ALERT SERVICE BULLETIN

NO. 222-00-86

Model 222 and 222B

HYDRAULIC ACTUATOR SUPPORT P/N 222-040-125-001, INSPECTION OF

**Hydraulic Actuator Support
Assembly P/N 222-040-125-001
Figure 1**

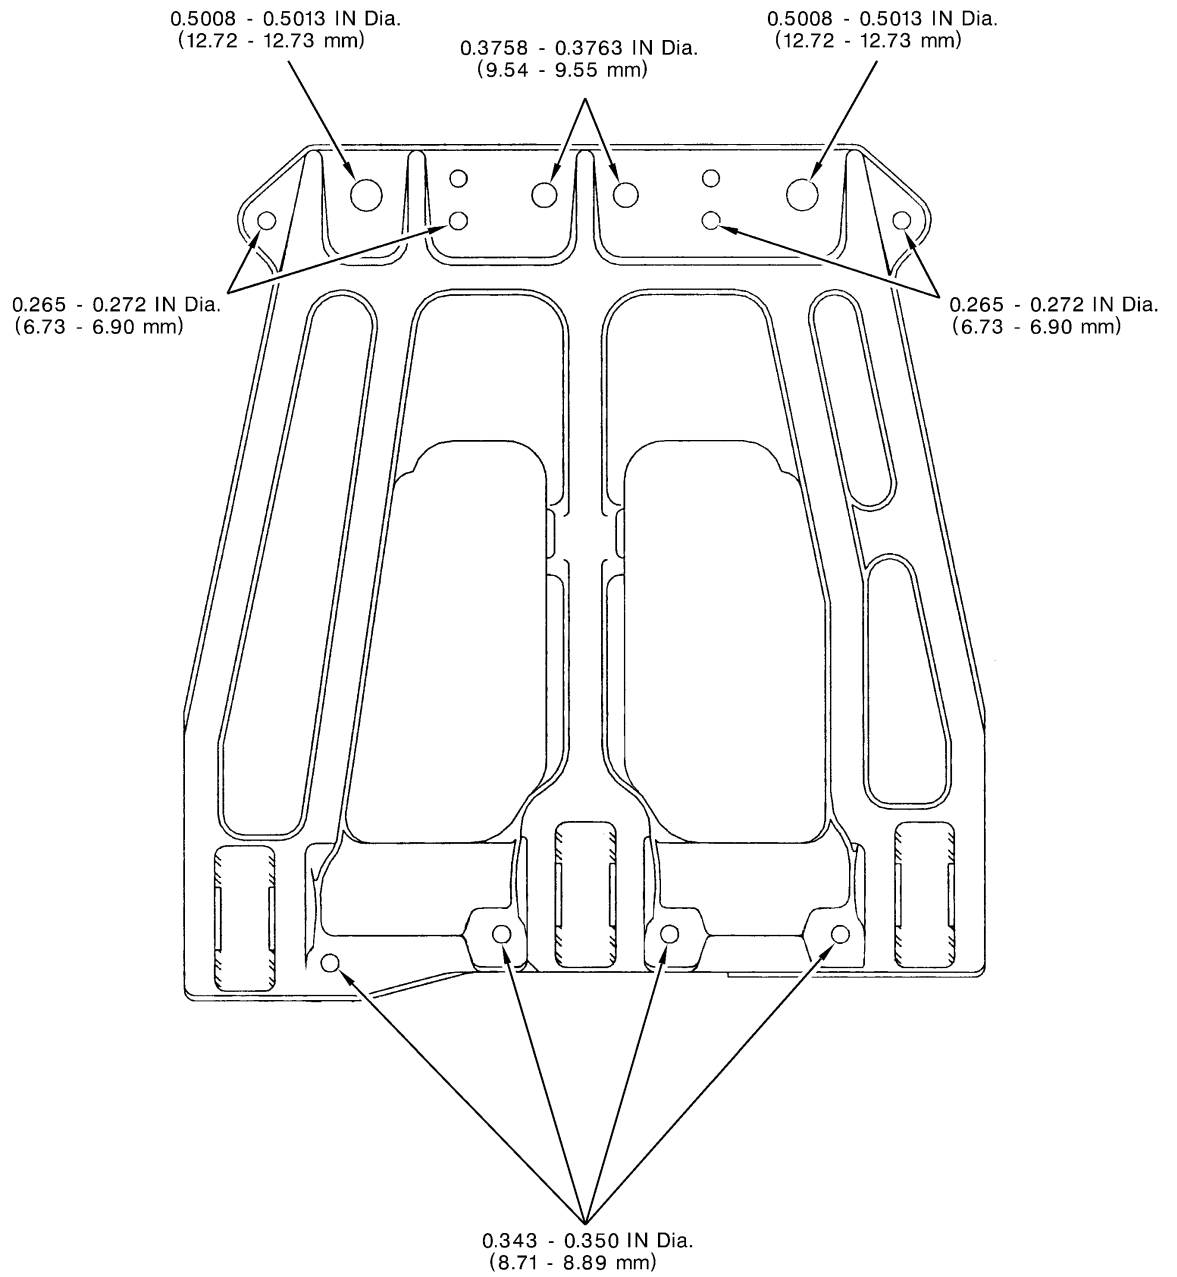
5. If required, inspect the support P/N 222-040-125-001 in accordance with instructions in BHT-222-CR&O-2, Chapter 63. The holes at the lower and upper end of the support were manufactured to the dimensions shown in figure 1.

**Transmission Top Case
Assembly P/N 222-040-061-101
through 105
Figure 2**

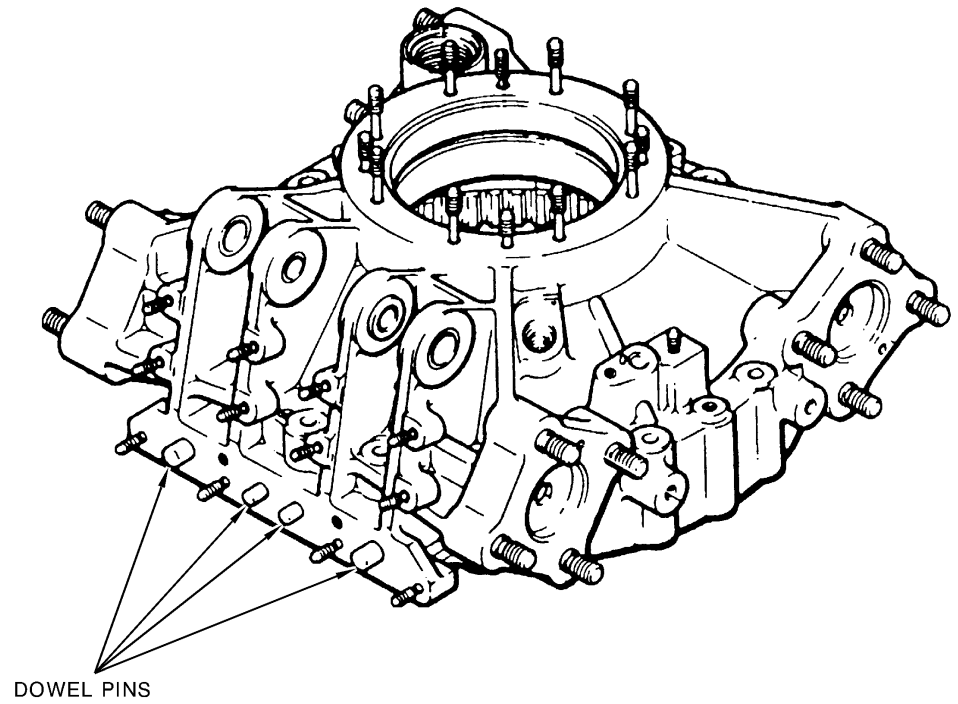
- c) Inspect the dowel pins in transmission case for damage, fretting, corrosion and looseness. The large outboard pins should measure 0.500 inch minimum and protrude 0.55 inch from the surface of the case. The small inboard pins should measure 0.375 inch minimum and protrude 0.45 inch from the surface of the case. Refer to Figure 2
